Valley of the Moon Park Site Plan Update

Advisory Group Meeting #2

April 15, 2014 • Federation of Community Councils Office

Illustration 2: Design Alternative 2

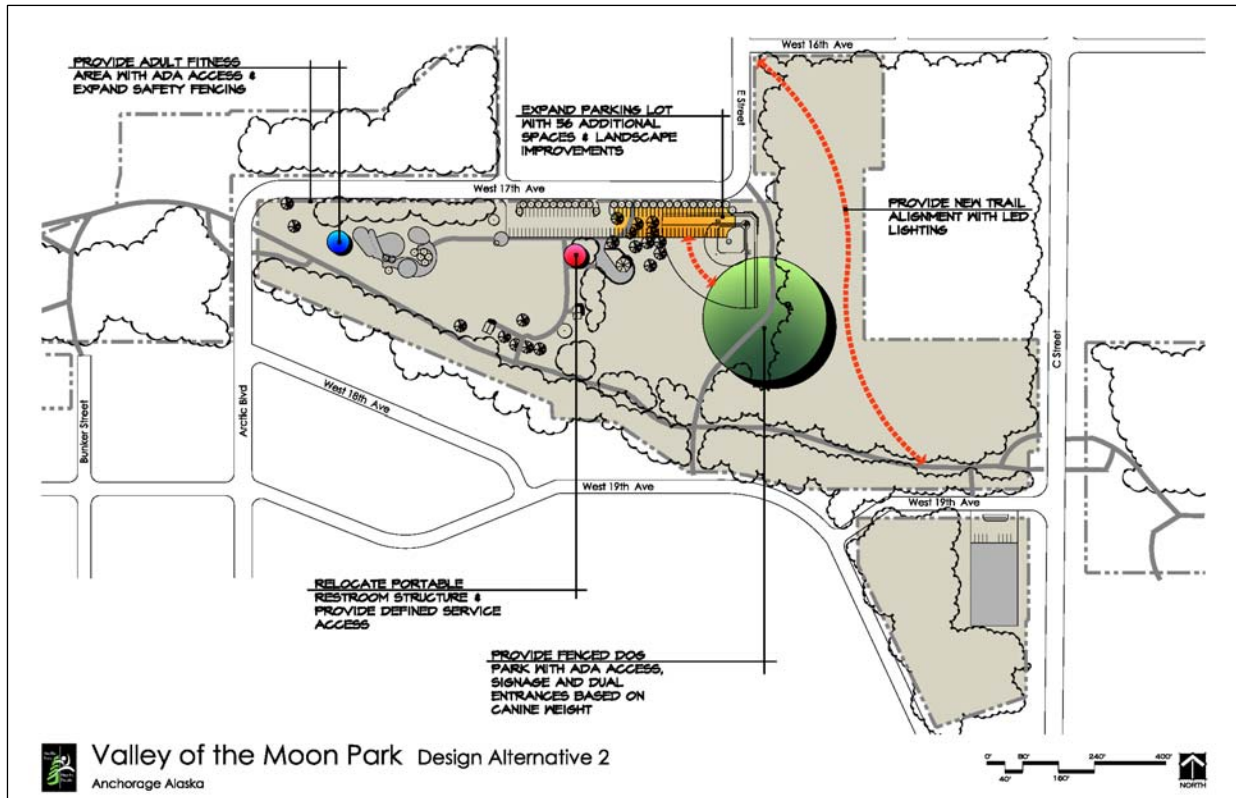
- Does not like the idea of moving the community garden as proposed in concept #4; “it takes a long time to make a good garden”, “I don’t like being on display like a zoo animal” referring to the idea of a highly visible community garden in the middle of the Park
- Likes the dog park in concept #2 but prefers the dog park moved closer to the parking lot - “nobody is going to hang out between the dog park and parking lot”
- Adult Fitness: likes location near playground
- Feels that access between 16th and E St to the parking lot in concept #3 will be dangerous
- Does not like the bike path in concept #2, cites that as a woman there is a feeling/perception of danger of traveling through the woods

- Strongly dislikes the new bike trail alignment in concept #2; cites that any new trail will need visual buffers which will lead to additional tree removal

- Likes concept #2; it is the only concept that addresses the homeless population
- Move dog park closer to the parking lot in concept #2
- Likes the expanded community garden in concept #3
- Does not like the permanent volleyball courts

- Does not like feel the need to keep the ball field, cites “not a fan of baseball at the ball fields”, “soccer is exploding in Anchorage
- Prefers that dog park activities are separate from other activities, tucked into an edge
- Prefers concept #2
- Is “not crazy about the volleyball courts”
- Likes the idea of expanding the open space

Illustration 3: Design Alternative 3

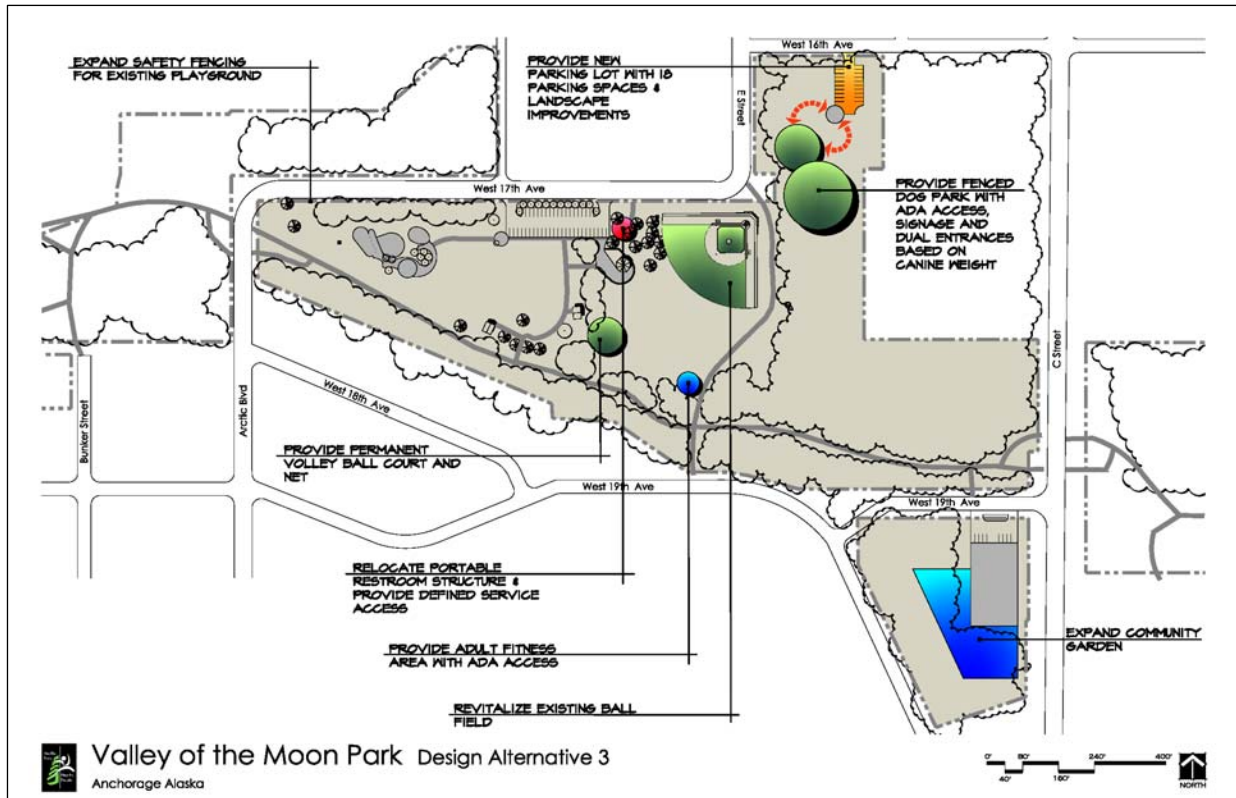
- Likes concept #4 because the dog park is separated from the other uses
- Feels that it is okay to use the undeveloped E St/16th Ave area of the park for active uses
- Supports concept #3 (prefers over #4)

- Likes permanent volleyball court in concept #3
- Does not like the dog park and community garden switched as proposed in concept #4
- Likes expanding the community garden (concept #3) but closer to 19th Ave
- Sees an opportunity for education at the community garden

- Clearly feels that concept #3 is the best
- Would like to add the Children’s Forest from concept #4 to concept #3 and include archway entrances in the design
- Prefers adult fitness station near the playground

- Proposes aligning the N/S bike trail on the east side of the E St bollards from park to 15th Ave to improve safety
- The dog park in concept #3 has the least visual impact

- Not interested in building a large dog park
- Expanding the community garden as proposed in concept #3 is okay
- Likes to keep the open field on the east side of the park for open play

Illustration 4: Design Alternative 4

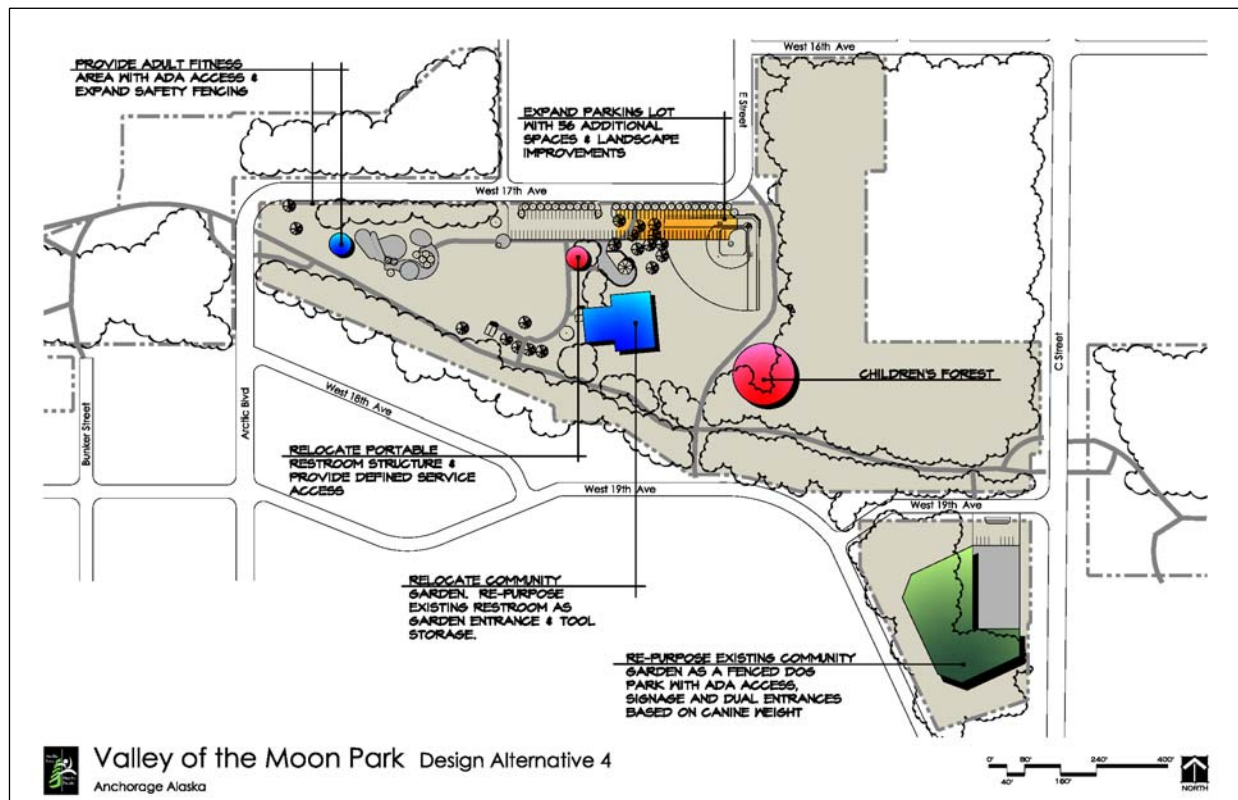
- Does not like community garden in the middle of the park because the open space is often used for picnics and play (concept #4); if community garden is moved it would be preferable to move it to the current location of the ball field to preserve the open space
- Likes adult fitness area by the playground
- Likes driving by community gardens on C Street and watching it grow through the season
- Likes concept #2: dog park in woods, re-routed bike path through the woods, and extra parking
- Remove the dugouts and replace with benches to prevent undesirable behavior taking place in the dugouts and to eliminate hiding places and litter
